147 Major St — HVAC clash mark-up

HVAC Designs LO# 113963 (HVA 26 167838) vs permit 26 167838 BLD 00 · PalmView BIM review · Oct 22, 2026

Two systems: F-1 basement (basement + main floor from below) · F-2 2nd-floor mech room (2nd + 3rd floors from the 3rd-floor joist space).

Sheet Title
BASEMENT HEATING LAYOUT

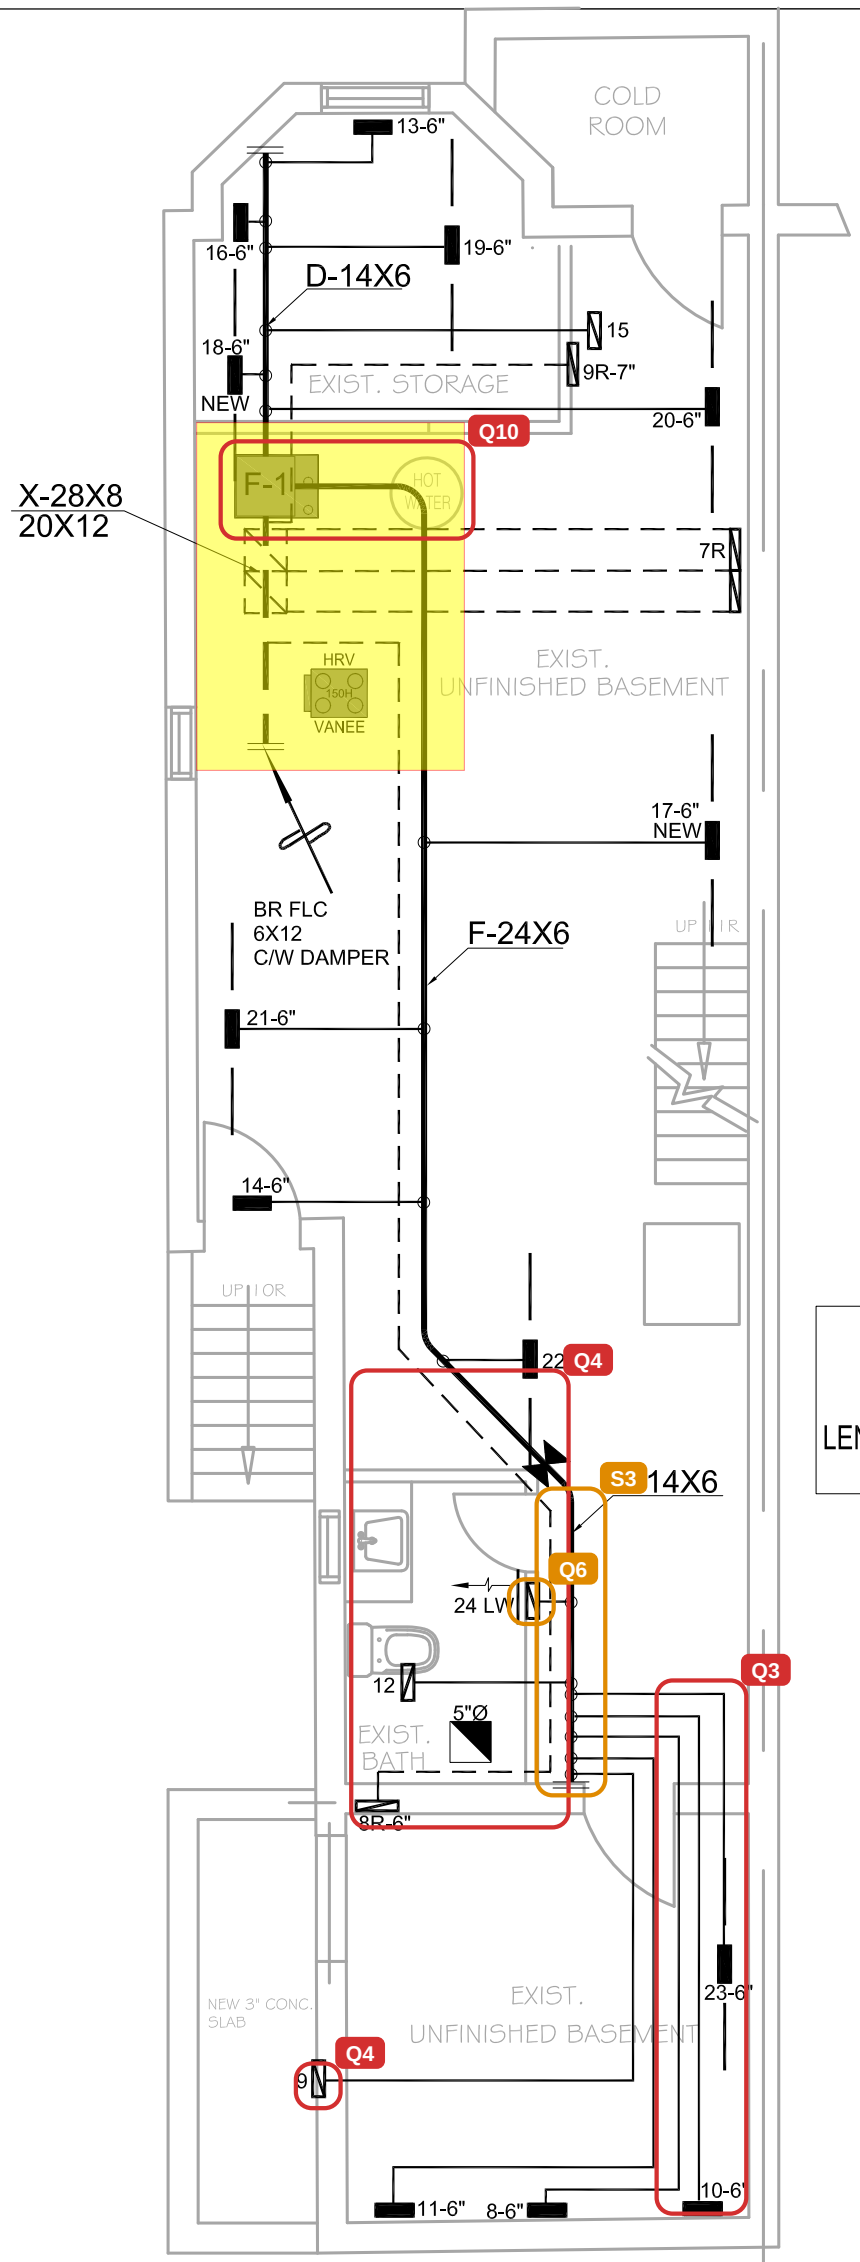
Q3 **Rear branches 8, 10, 23 through the old rear foundation**

Core three holes in the brick, or route all rear branches through the existing 30" opening. Owner: HVAC sub. Status: OPEN.

Q4 **Supply 9 and return 8R sit on old foundation walls**

Both stacks land on top of existing masonry (powder E wall, pantry/storage double wall). Relocate. Owner: HVAC Designs. Status: OPEN.

Q10 **F-1 new or existing; hot water tank vs plenum**

F-1 not tagged existing and sits where the permit shows the existing H.E. furnace. Takeoff runs over the tank vent. Owner: PalmView. Status: OPEN.

Q3 Rear branches 8, 10, 23 through the old rear foundation

Q4 Supply 9 and return 8R sit on old foundation walls

Q6 7" return stacks in 2x4 walls (1R–6R, 9R) and 6" supply stacks

Q10 F-1 new or existing; hot water tank vs plenum

S3 Trunk E ends ½" off the old rear wall

Sheet Title
FIRST FLOOR HEATING LAYOUT

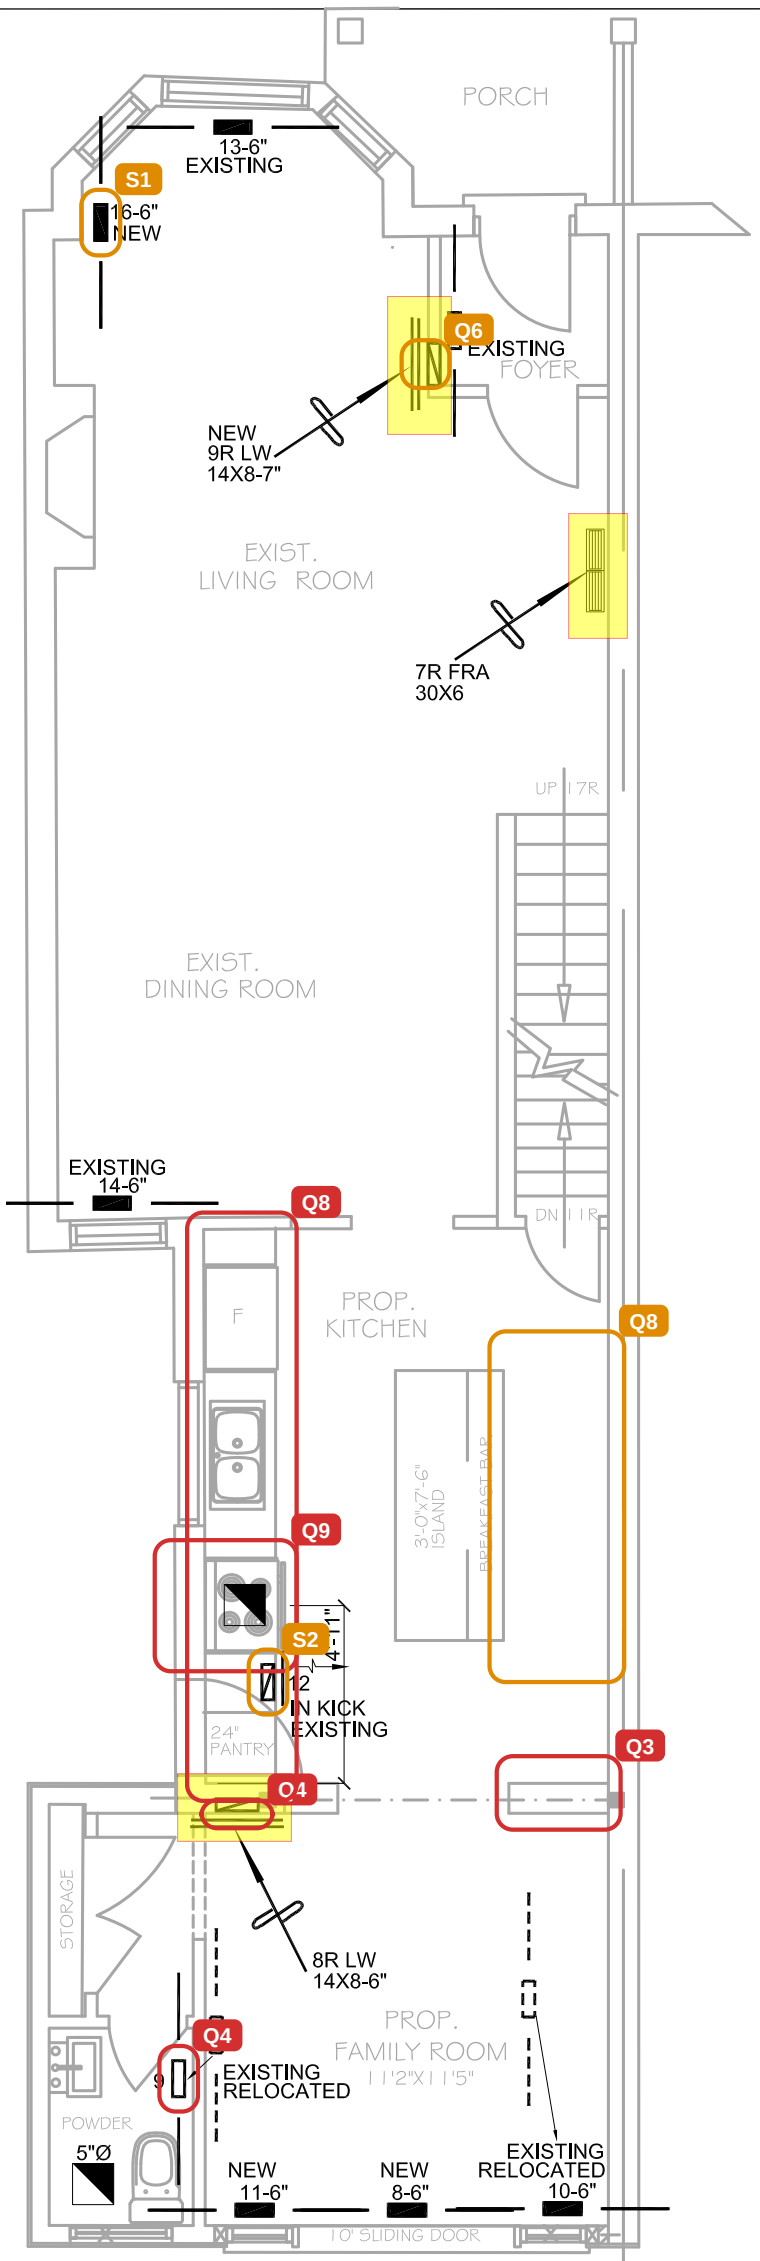
Q8 **Kitchen sizes: range, fridge, run length and aisle**

Permit shows a 30" range and 34" fridge; Miele range and fridge are 36". Cabinet set 186.5" vs 184.6" wall. Aisle to the stair is 34.9". Owner: Cabinet shop / PalmView. Status: OPEN.

Q9 **Kitchen hood exhaust not designed**

Elica Trento insert on the south wing wall under the 2nd-floor overhang. No duct or termination drawn. Owner: HVAC Designs. Status: OPEN.

- Q3 Rear branches 8, 10, 23 through the old rear foundation
- Q4 Supply 9 and return 8R sit on old foundation walls
- Q6 7" return stacks in 2x4 walls (1R–6R, 9R) and 6" supply stacks
- Q8 Kitchen sizes: range, fridge, run length and aisle
- Q9 Kitchen hood exhaust not designed
- S1 Supply 16 boot tight to the bay corner
- S2 Supply 12 kick register under the pantry

Sheet Title
SECOND FLOOR HEATING LAYOUT

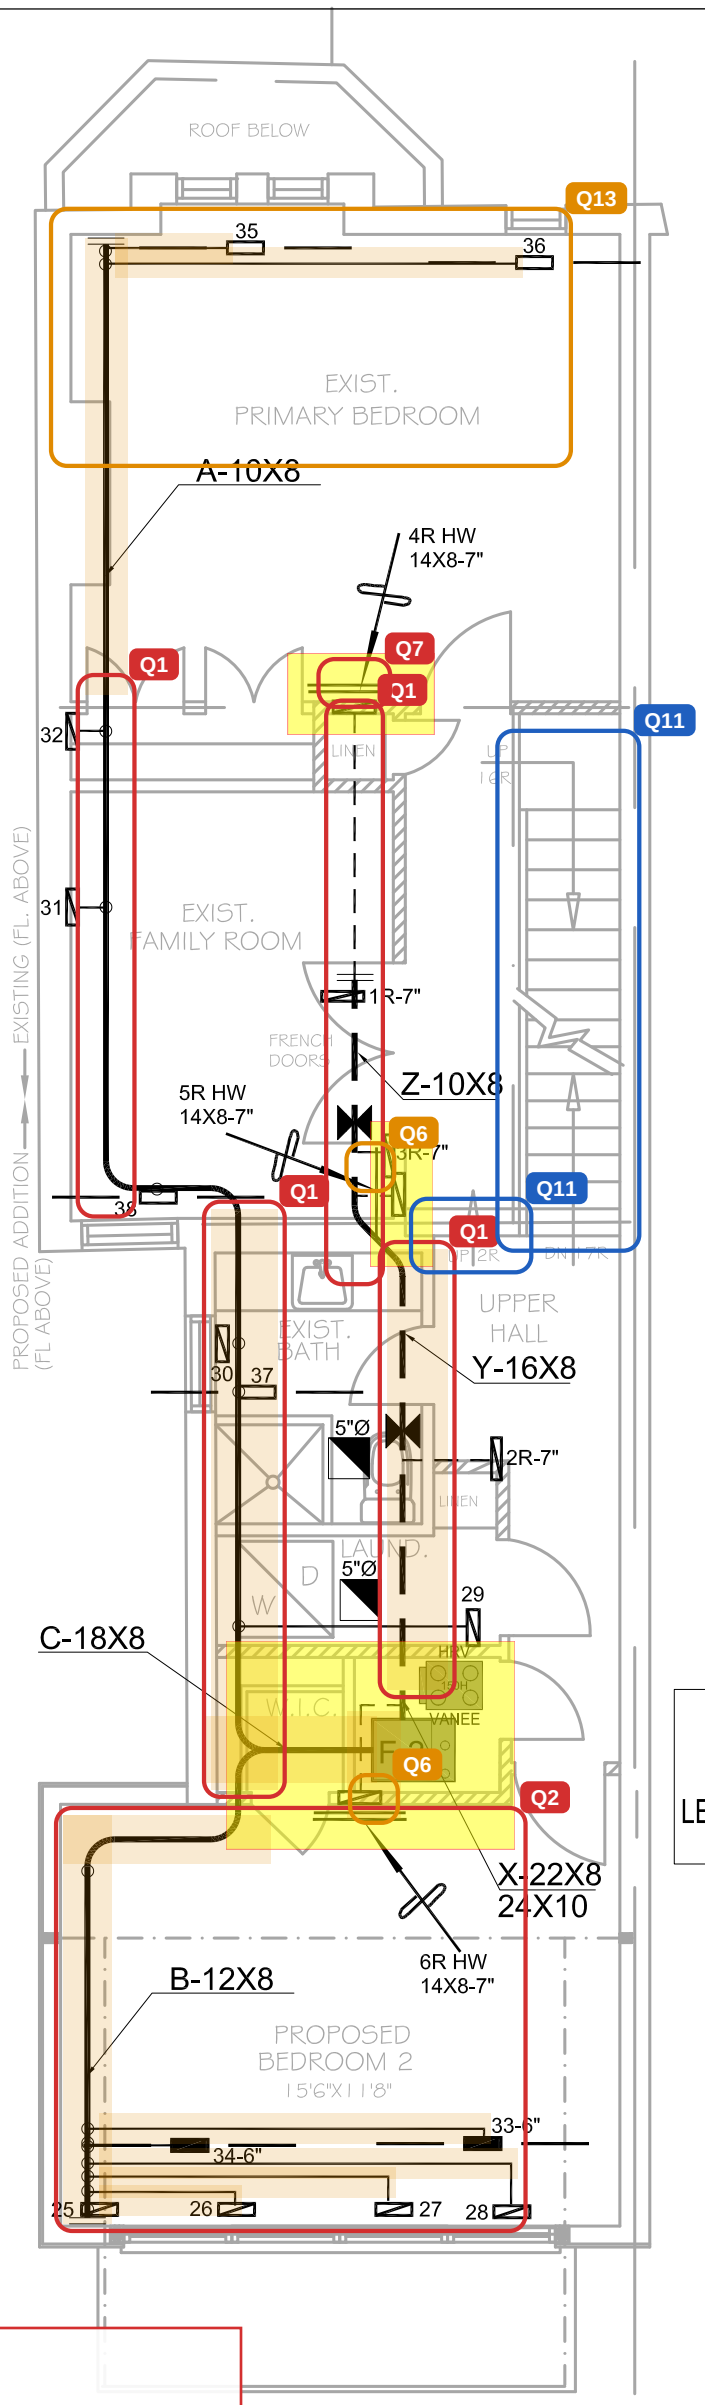
Q1 **2nd-floor ceilings for the F-2 trunks**

Rear (lower) level, 10'-4½" ceiling: drop the hall / bath / laundry / W.I.C. / bedroom 2 ceilings flat to ~9'-6" to hide C, B, Y, 6R and branches 25-28, 33/34 (or box them at 9'-8"). Front (upper) level, 9'-0½" ceiling: trunk A along the south wall and return Z in the family room need 14" bulkheads at 8'-4", or a reroute. Owner: PalmView / client. Status: RESOLVED.

Q2 **Bedroom 2 ceiling: joist direction and trunk B on LVL1**

Confirm the cantilever TJIs over bedroom 2 run front-to-back (balcony). Trunk B sits on the south LVL1; 5 branches cross 26 cantilever joists. Owner: Kott / Rona + engineer. Status: SITE.

Q7 **Return 4R stack vs the LVL5 flush beam**

Grille is on the closet wall right under LVL5; the stack cannot pass the beam. Owner: HVAC Designs / engineer. Status: RESOLVED.

Q11 **Stair direction 2nd → 3rd, and the size of the 2nd-floor step**

Plans A8/A9: new stair stacked over the existing one, rising front-to-rear. Section A-A draws it rising rear-to-front. Step: section A-A framing shows 16" (2R at 8"); the rear and south elevations show 1'-9" (10'-11" vs 9'-2"). Model uses 16". Owner: PalmView / designer. Status: OPEN.

Q13 **Front roof space over the primary bedroom**

Trunk A (first 6.7 ft) and branches 35/36 are under the existing front roof. If that space is outside the insulation, ducts need R-12 + Class A sealing (permit note). Owner: PalmView. Status: OPEN.

Q1 2nd-floor ceilings for the F-2 trunks

Q2 Bedroom 2 ceiling: joist direction and trunk B on LVL1

Q6 7" return stacks in 2x4 walls (1R–6R, 9R) and 6" supply stacks

Q7 Return 4R stack vs the LVL5 flush beam

Q11 Stair direction 2nd → 3rd, and the size of the 2nd-floor step

Q13 Front roof space over the primary bedroom

Oct 22 - Shifts made with the drop (HVAC sub to follow)

Hung under the joists, three runs moved off wall top plates: trunk C 2" east (was 1.4" into the notch wall), return Y 5" east (was over the bath east wall), 6R run and stack 5" east (was over the W.I.C./mech wall). Still to place on site: the C-to-A tie (10x8 at the step line) lands between the family-room rear wall and the bath north wall, which are only 7.8" apart - box it on the family-room side.

Oct 22 - 2nd floor is split-level

Front (existing house, y < 28 ft) is the upper level at 113.85; the kitchen-wing / addition part steps down. Measured 16" from the section A-A framing; UP 2R at the stair landing; flush LVL5 on the step line. Ground stair 17R lands on the lower level. Model updated.

Sheet Title
THIRD FLOOR HEATING LAYOUT

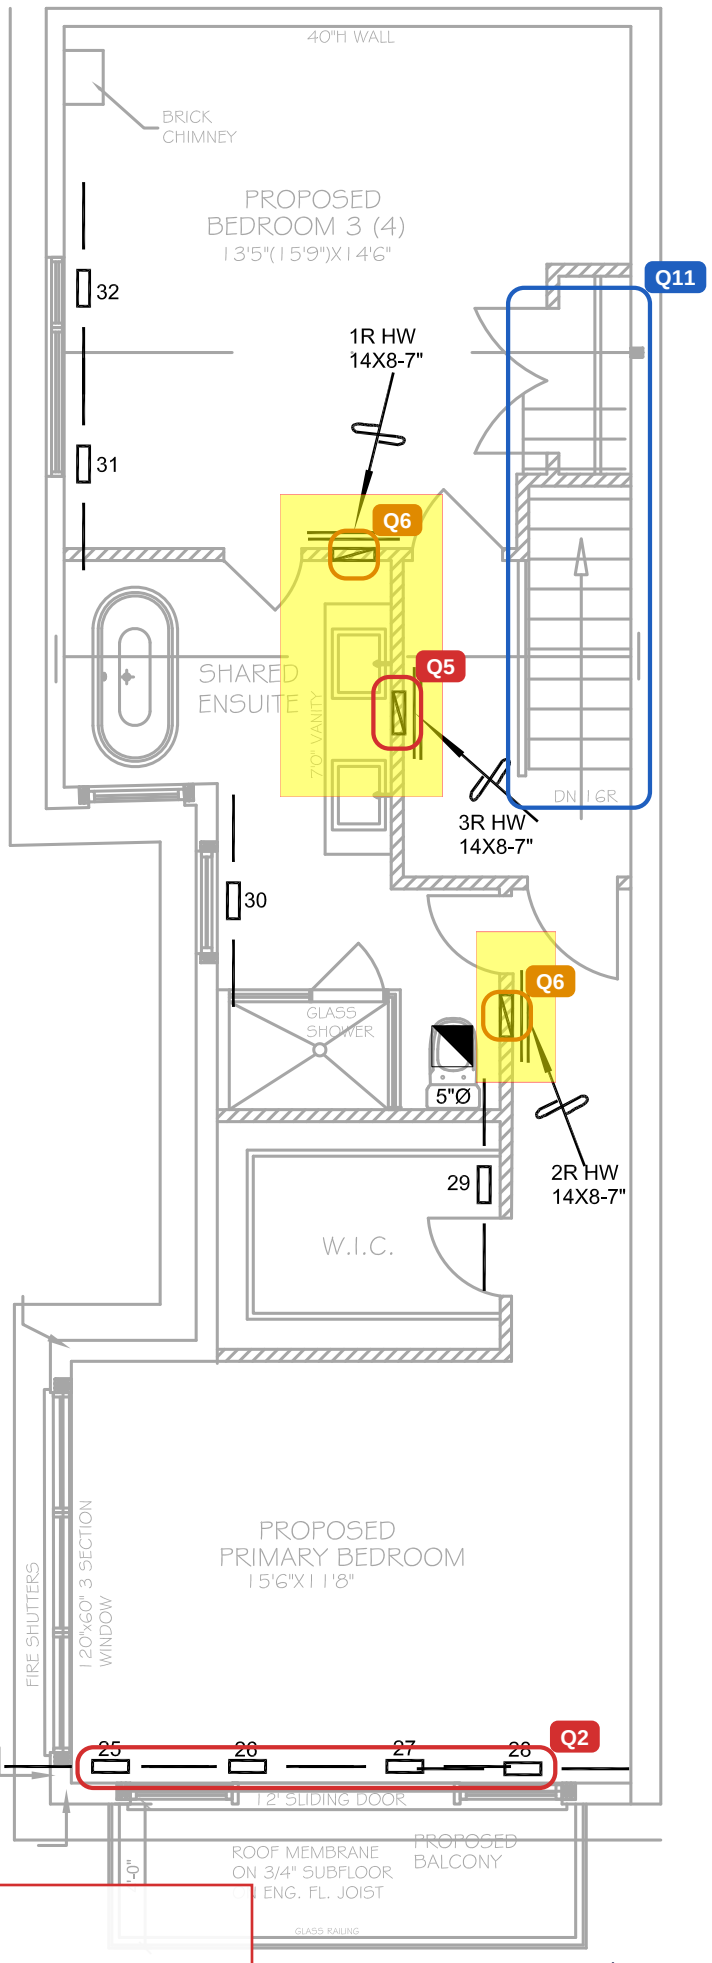
Q5 **Return 3R on the ensuite vanity / mirror wall**

High-wall grille + 7" stack behind the 72" vanity, mirrors, sconces and feature tile. Owner: HVAC Designs / designer. Status: OPEN.

Q2 Bedroom 2 ceiling: joist direction and trunk B on LVL1

Q5 Return 3R on the ensuite vanity / mirror wall

Q6 7" return stacks in 2x4 walls (1R–6R, 9R) and 6" supply stacks

Q11 Stair direction 2nd → 3rd, and the size of the 2nd-floor step
